# JE Fuller/ Hydrology & Geomorphology, Inc.

September 3, 2008

RE: Talavera Floodplain Delineation Study

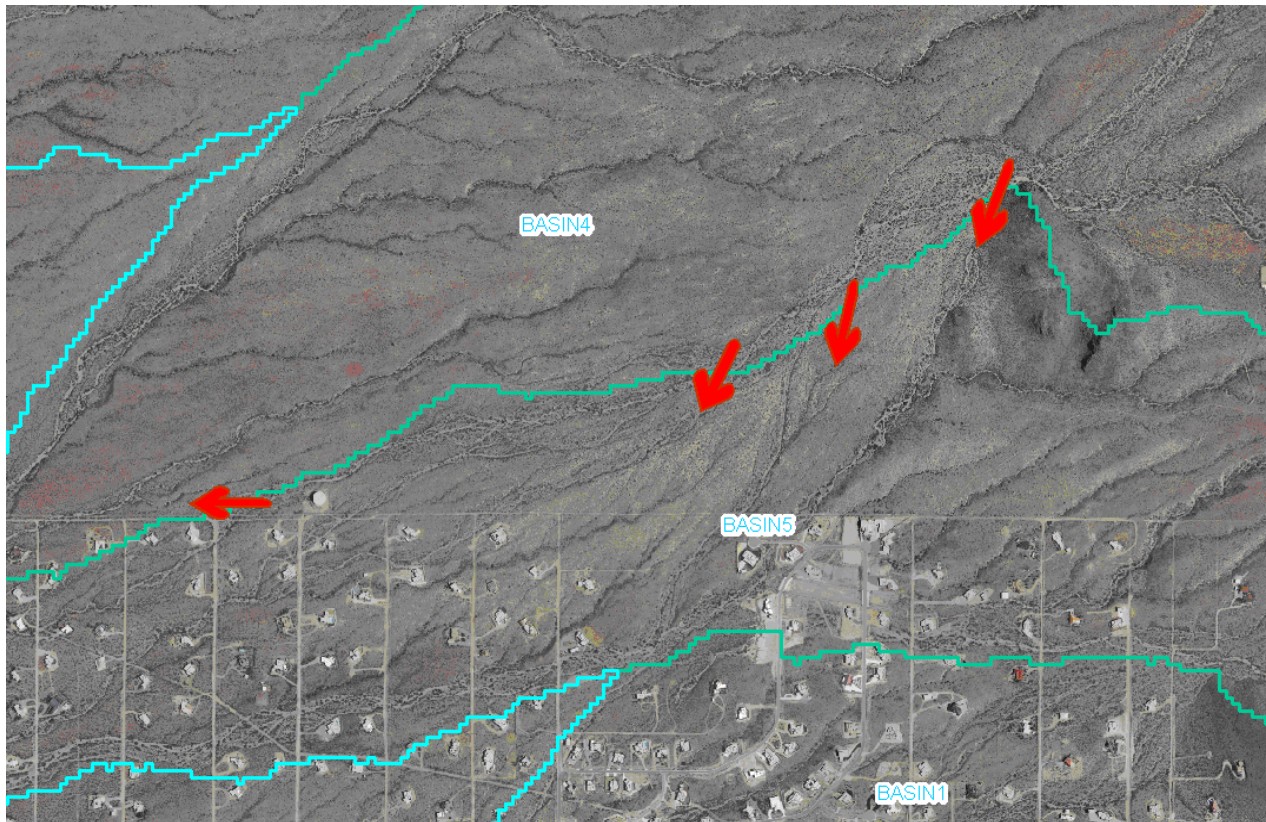
- **Subbasin Delineation.** The watershed subbasin delineations were generated using automated procedures (software) and digital elevation model (DEM) data. As is often the case when using automated procedures, the subbasin delineations are crude but reasonable where the topography is well defined, but have significant problems in areas of complex topography. The subbasin delineations would have been improved by applying engineering judgment, and by using visual interpretation of the topographic mapping and aerial photography. URS made two key errors. First, flow paths frequently cross the subbasin boundaries. Second, the concentration points are not located at the subbasin outlets. Examples of the first error are shown in Figures 1 and 2, where the aerial photography clearly shows flow paths crossing the delineated boundary between BASIN4 and BASIN5. The same error is depicted in Figure 3, in which the USGS topographic quadrangle mapping clearly depicts a flow path that crosses a subbasin boundary. The correct method of delineating the watershed boundary would be to place a concentration point where flow crosses from one subbasin to another, or to identify a split flow point. The consequence of incorrectly delineating subbasin boundaries is that the basin area is the primary variable used to estimate the 100-year discharge. Therefore, errors in basin area are directly correlated to errors in discharge. If the discharge is incorrect, the floodplain delineation will be incorrect.

Figure 4. Aerial photograph of the BASIN4 subbasin showing significant flow paths within a single subbasin.

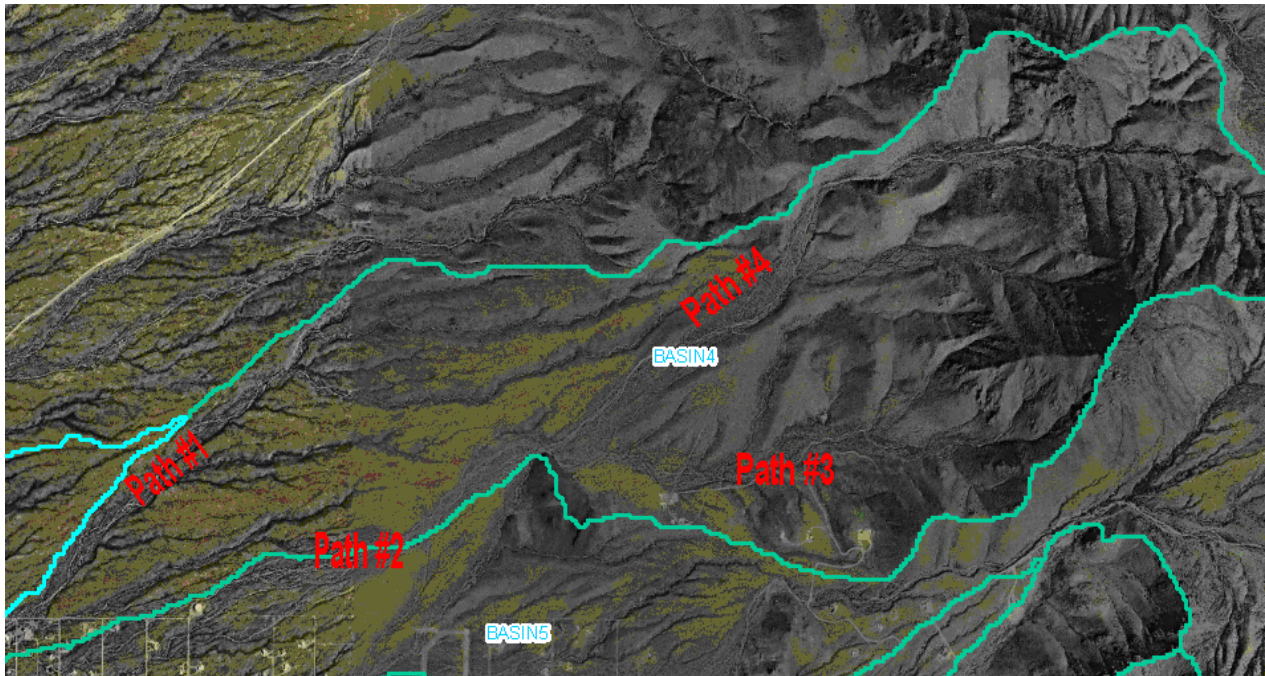
- **Subbasin Size.** The individual subbasins used in the hydrologic modeling are rather large. Because of their large size, they tend to include more than one significant flow path within their boundaries. Typically, subbasins are delineated so that each concentration point represents one significant flow path and/or confluence point. For example, as shown in Figure 4, the BASIN4 subbasin has four significant wash segments, some of which breakout into BASIN5 and BASIN7 at various locations. These flow paths and breakout points are also discernable on the USGS topographic maps and could have been identified without inspection of the aerial photographs. The subbasin delineations should be refined to better represent the flow concentration points and discharge values at the floodplain delineation reaches. The consequence of this error on the floodplain delineation becomes more apparent because of how URS chose to enter the discharge estimates into the delineation model, as discussed below.

Figure 5. Watershed subbasin map showing flow inflow points used for FLO2D modeling. Note the odd location on the northern area of the watershed chosen for inflow for BASIN7 (2380 cfs).

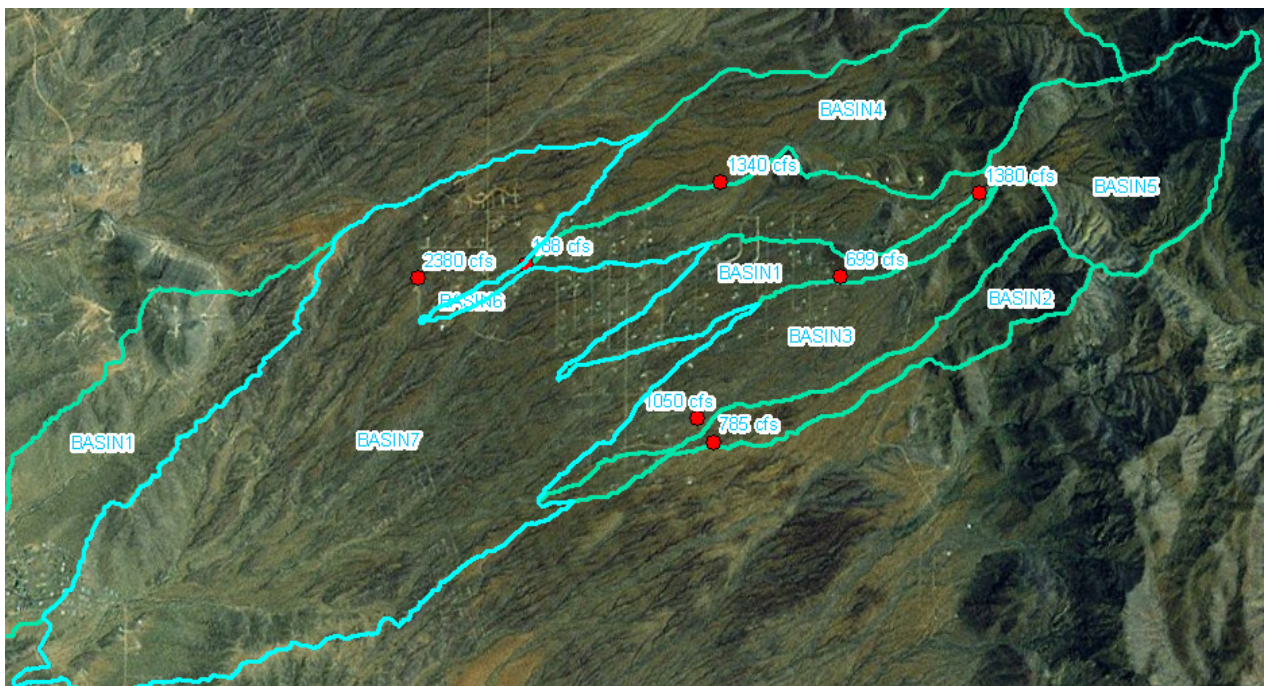
- **Discharge Inflow Points.** The inflow values in FLO2D model are based in part on the 100-year discharge values presented in the URS Hydrology Report. However, the 100-year discharge values taken from the Hydrology Report were inexplicably applied at single grid cell locations in the FLO2D model, despite the fact that the floodplain at the inlet point spans many individual grid cells. Also, for

some unknown and inexplicable reason, URS applied the discharge values at grid cells located along a single flow path within each subbasin, rather than at the concentration point at the outlet of the subbasin. These inflow locations appear to be chosen arbitrarily, with no explanation provided to justify their selection. For example, in BASIN7, which covers an area of 92 square miles at the downstream end of the watershed, discharge is entered at a grid located on the northeast side of the basin (Figure 5), completing missing several of the key flow paths. Since the FLO2D model has the ability to model rainfall runoff, there was no need to take the unusual approach used by URS. Use of FLO2D's rainfall component would also distribute floodwater to all the washes with significant capacity within the study area, whereas URS's approach lumped flows at single grid locations within the subbasins. The red dots in Figure 5 depict the flow inflow locations used in the URS delineation.

Figure 6. Hydrographs from URS HEC-HMS modeling.

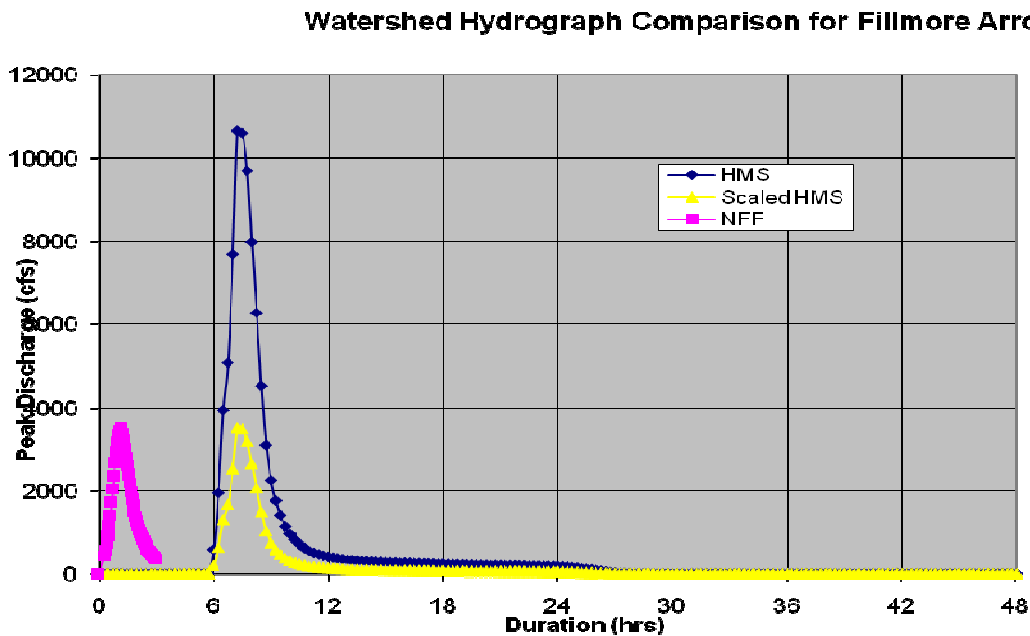
- **Hydrograph Shape.** 100-year peak discharge values were obtained from the regression equations. Since the regression equation does not provide any information regarding the shape of the flood hydrograph, the hydrograph shape required for the FLO2D model was approximated as an isosceles trapezoid shape that varies from zero cfs (non-flood condition is dry streambeds) and the 100-year peak discharge. The hydrograph duration was “guess-timated” at 3 hours, with a time to peak of one hour, although no technical justification for the flow duration or rise time was provided in the TDN. Inexplicably, a constant peak discharge for a one hour duration was used over the second hour of the hydrograph. The flow hydrograph then decreases linearly to zero cfs over the third hour. There are a number of potential problems with the hydrograph used by URS for the FLO2D floodplain modeling, including the following:

- Duration. The URS HEC-HMS model computed a flow duration of approximately six hours (blue line on Figure 6), rather than three hour duration used by URS in the FLO2D model.

- Peak. A discharge at the 100-year peak flow rate sustained for a one-hour period is highly improbable. The HEC-HMS model results (and common sense) suggest a near instantaneous peak duration. The consequence of this error is that the total flow volume is overestimated, flood attenuation is underestimated, and floodplain limits are overestimated.

By contrast, the three hydrographs described in the Hydrology Report are shown in Figure 6, which was taken from the URS documents. The FLO2D hydrograph was not shown in the URS Hydrology Report and is not shown in Figure 6. The shape of the FLO2D hydrograph can be inferred from the data above.

*Figure 7. FLO2D flow depths showing grid size affect on floodplain delineation of a small channel. Note the obviously upland areas that are shown as flood prone and channel areas with equal depths to overbank areas.*

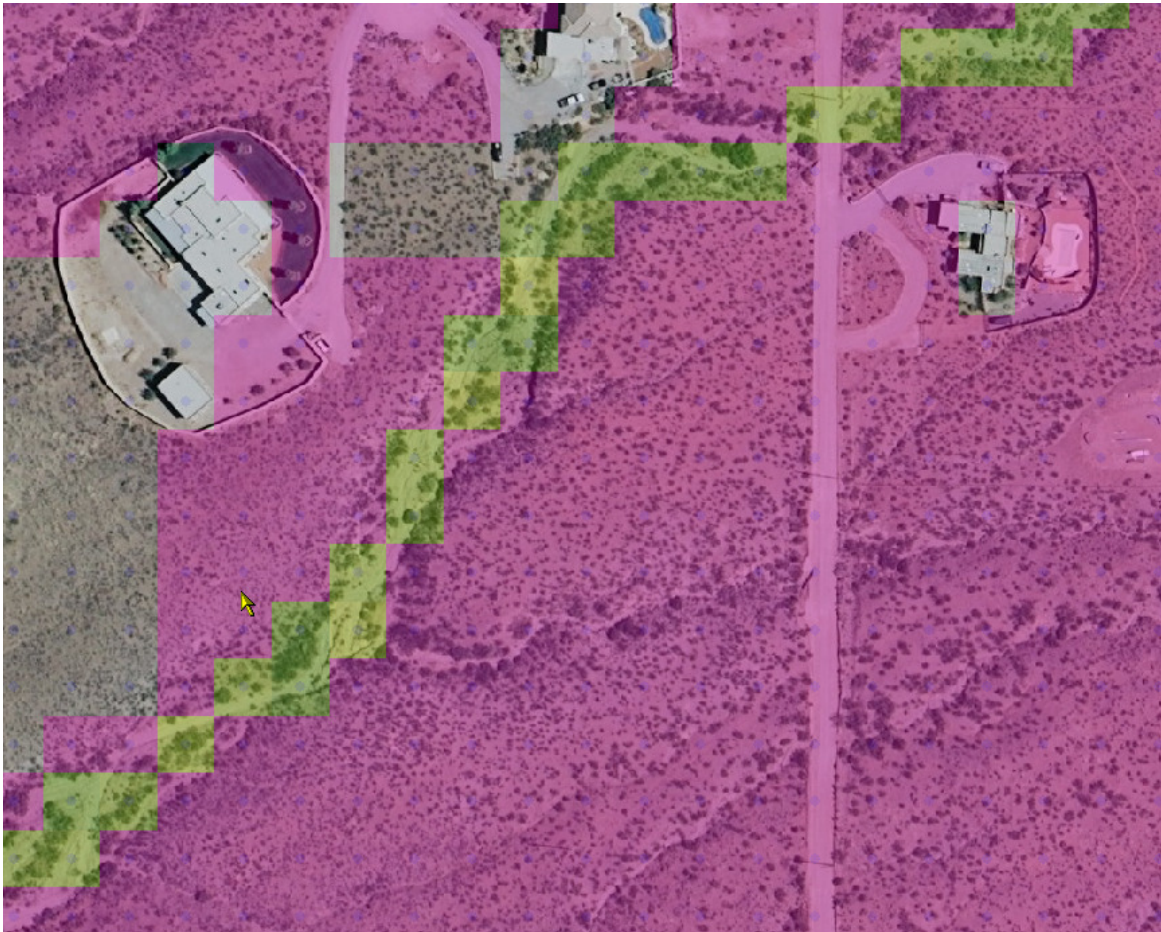
- **FLO2D Model Grid Size.** The FLO2D model uses a 50 foot grid element, meaning that a single value represents the elevation and hydraulic characteristics of a 50 ft x 50 ft area. Selection of very small grid sizes significantly slows the speed of the computer computations, but increases the resolution of

the mapping. Selection of large grid sizes speeds the computations (sometimes by days or weeks), but results in loss of resolution that may be critical if small watercourses are being mapped. For the case of the Fillmore watershed, the 50 foot grid size can be used to accurately model large areas with relatively uniform topography, but the representations of many channel geometries in the study area are grossly inaccurate, resulting in less flow in channels and more flow in the overbanks. Figure 7 shows an example of the affect of the grid cell size with respect to a moderately small channel in the study area. It can be seen in Figure 7 that channels with widths smaller than 50 ft and a single elevation representing the channel and overbank geometry do not accurately depict the actual flood limits.

Figure 8. FLO2D results showing areas of inundation of less than one foot (magenta).

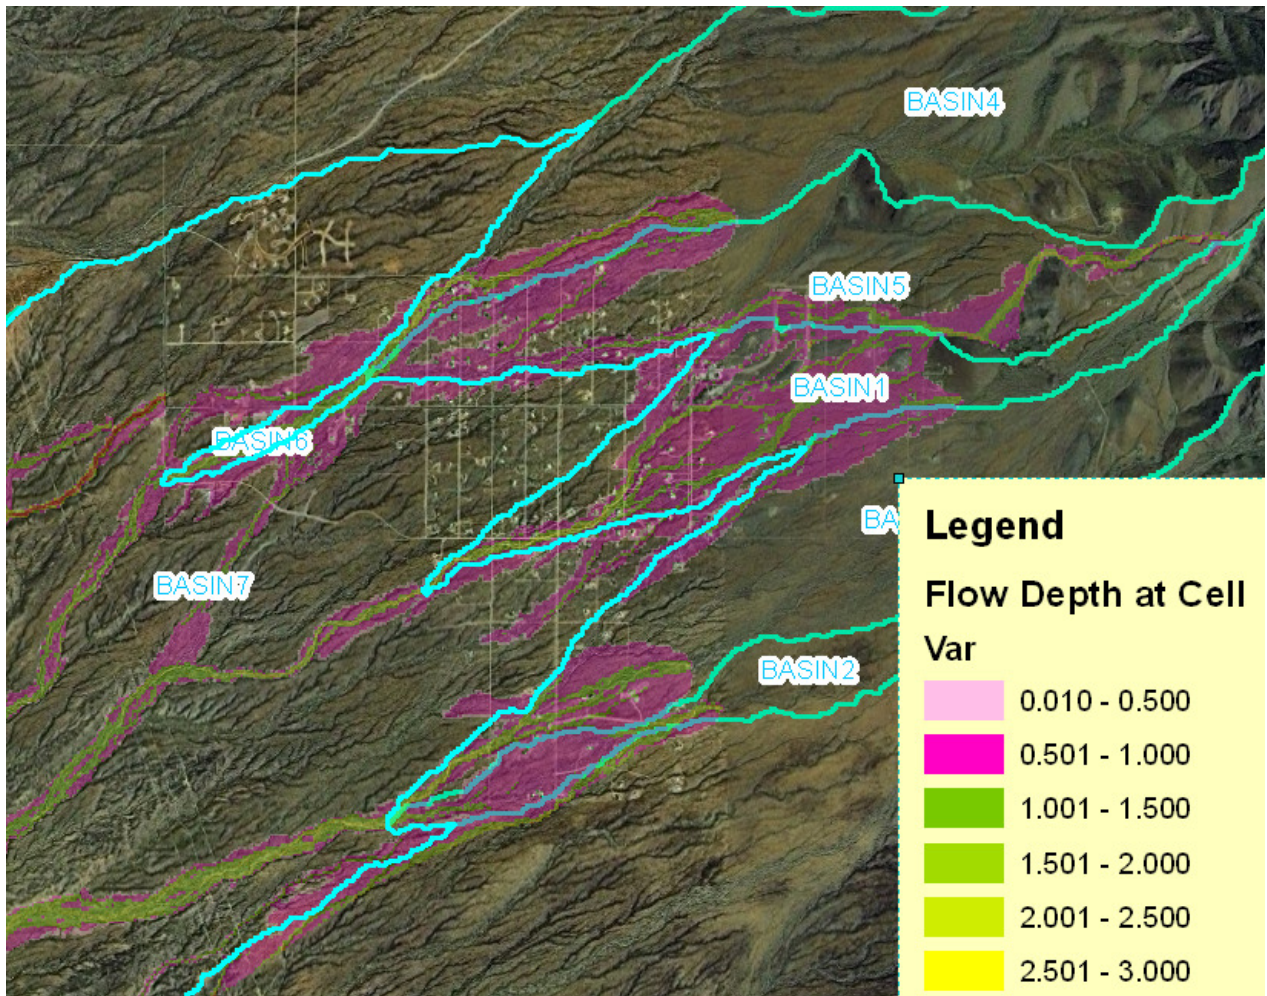
- **Flood Zone Delineation.** The Hydraulics Report states that the FLO2D output “...shapefile was then modified to eliminate any cells that had a depth less than 0.5-feet.....The resulting floodplain consists of Zone AO polygons of depths varying from 1-foot to 3-feet.” However, the flow depths from the FLO2D model results (Figure 8) show that majority of the inundated areas in the Fillmore watershed are less than one foot deep. These shallow flooding areas (<1 ft flow depth) could be delineated as Zone X, as mandated in the FEMA Guidelines (p. E-3, April 2003), but are mapped as Zone AO1 in

the URS floodplain delineation. Most of the Talavera subdivision falls within the less than one foot flow depth category.<sup>3</sup>
